## **REMARKS/ARGUMENT**

IN THE UNITED STATES PATENT AND TRADEMARK OFFICE

Serial No.: 10/722,635

For: SPRING CONTACT PROBE DEVICE FOR ELECTRICAL TESTING (As Amended)

**FIG. 1**

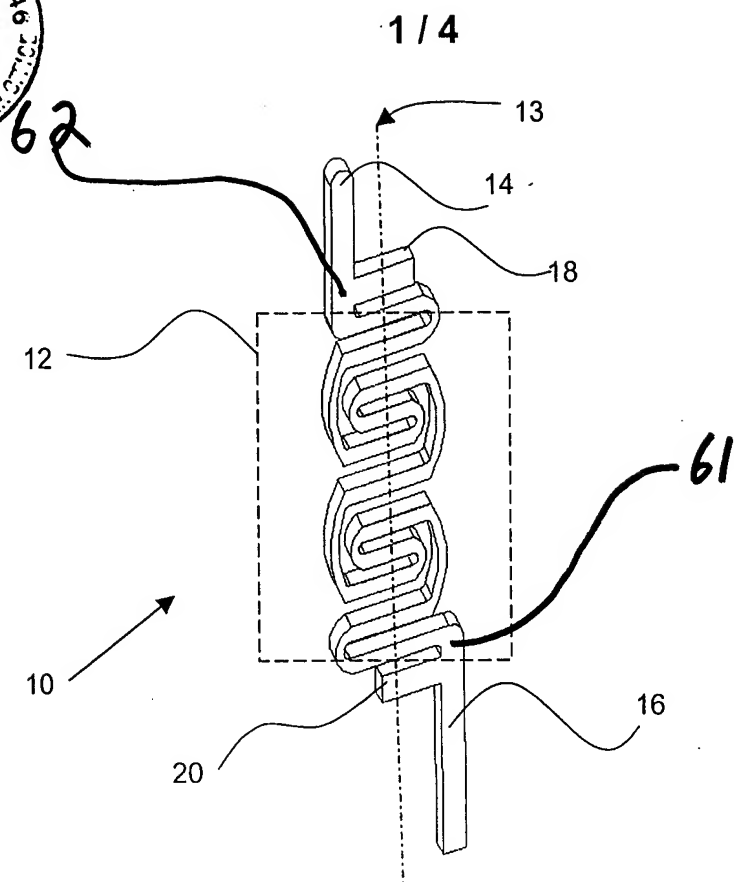
The drawings were objected under 37 C.F.R. 1.84 for including reference character "32," which was not referenced in the Specification; for using reference character "36" to refer to multiple components (i.e., the manual test jig and the guide blocks); and for not showing every feature as claimed.

Submitted herewith on a separate sheet of paper is a "Request for Entry of Proposed Drawing Corrections," together with a red-lined version of Figure 1 showing two new reference characters "61" and "62" labeling distal and proximal ends of the spring probe, respectively. Furthermore, the Specification has been amended to make clear that the manual test

jig is referred to by reference character "32," not "36." It is respectfully submitted that the amendments to the Figures and Specification do not add new matter, have adequate support throughout the Specification as originally filed, and adequately address the Examiner's drawing concerns. Accordingly, it is kindly requested that the objections to the drawings be withdrawn.
